RESOLUTION NO. 1681

A RESOLUTION APPROVING PEDERSEN VALLEY PART THREE PHASE ONE,
LOT 23 SITE PLAN

Re: Pedersen Valley Part Three-Phase One, Lot 23

SITE PLAN

SITE LAYOUT AND DIMENSION PLAN

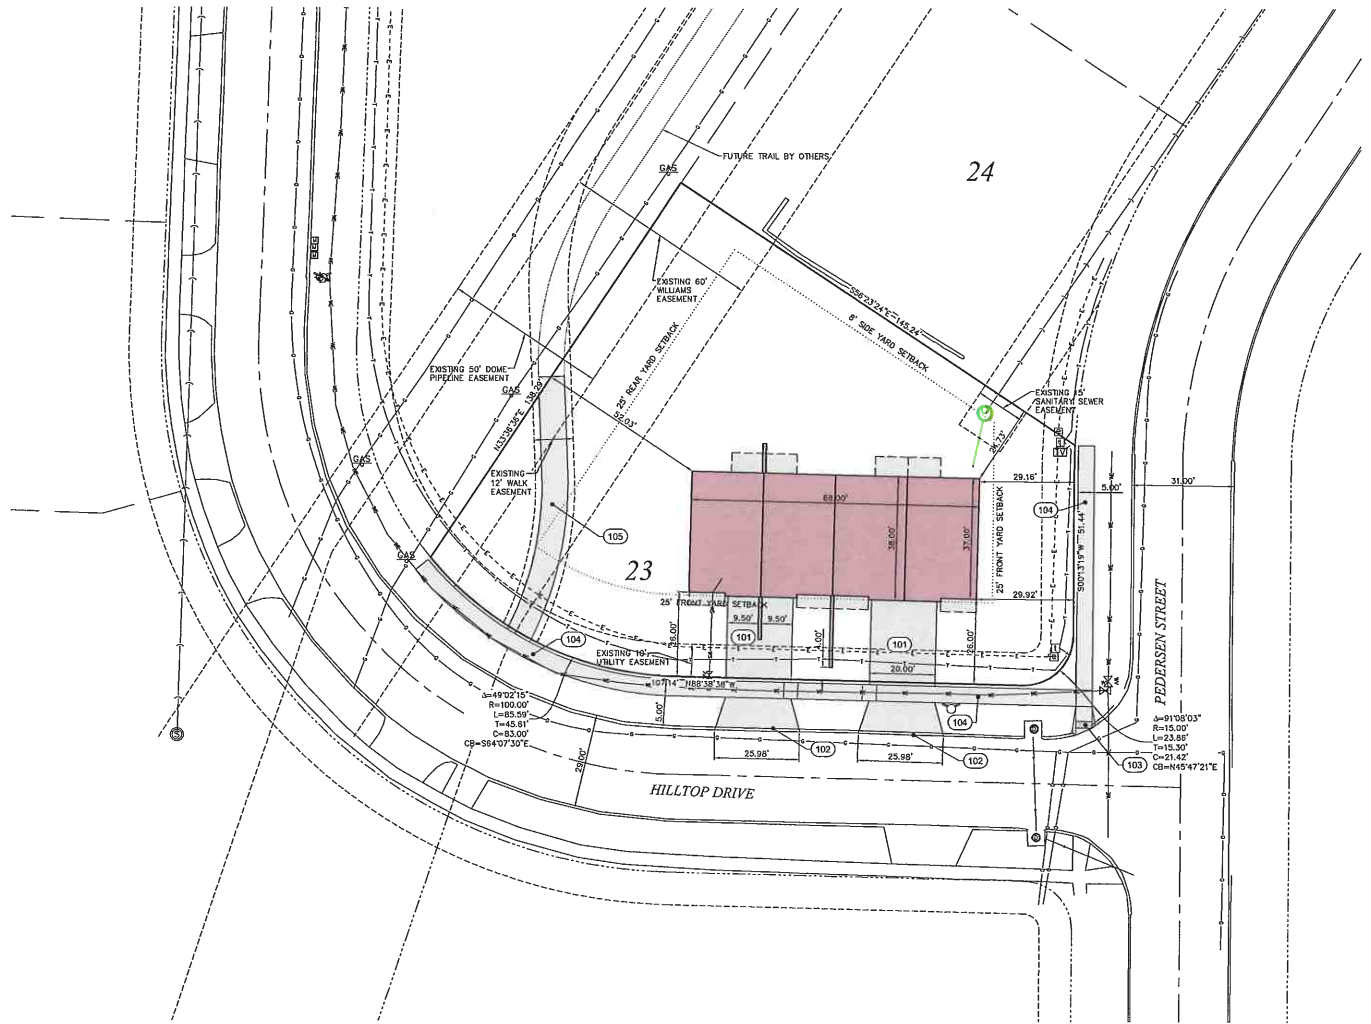
2. A sidewalk ramp should be constructed for the crossing at Hilltop Drive to line up with the existing ramp on the south side.
Revised accordingly.
3. Grading for the trail should be completed as part of the lot development prior to placing landscaping.
Grading for the trail portion on the property has been added.

4. Resolution 720 addressed retaining walls and requires that the retaining wall be no closer than 4 feet from a property line. The wall between the center two units extends closer to the property line than the 4 feet minimum.
The wall has been revised.

SITE UTILITY PLAN

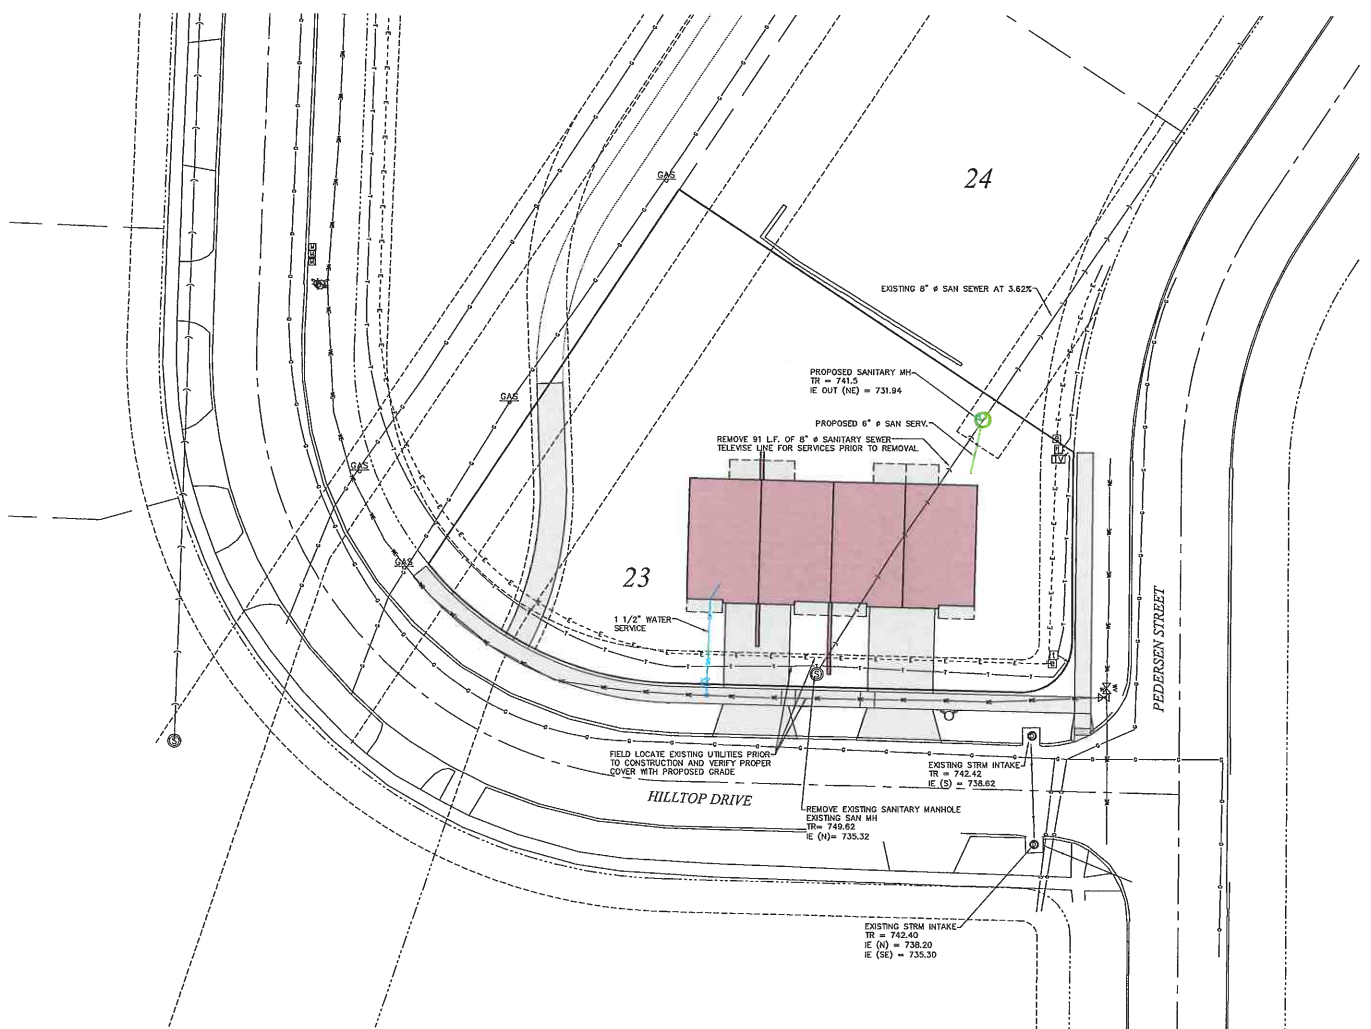
1. The building will be situated over an existing sanitary sewer line. The line is proposed to be abandoned across lot 23. The line should be televised prior to final approval of the site plan to confirm there are no active services in the reach to be abandoned.
A note has been added televised the line prior to removal.
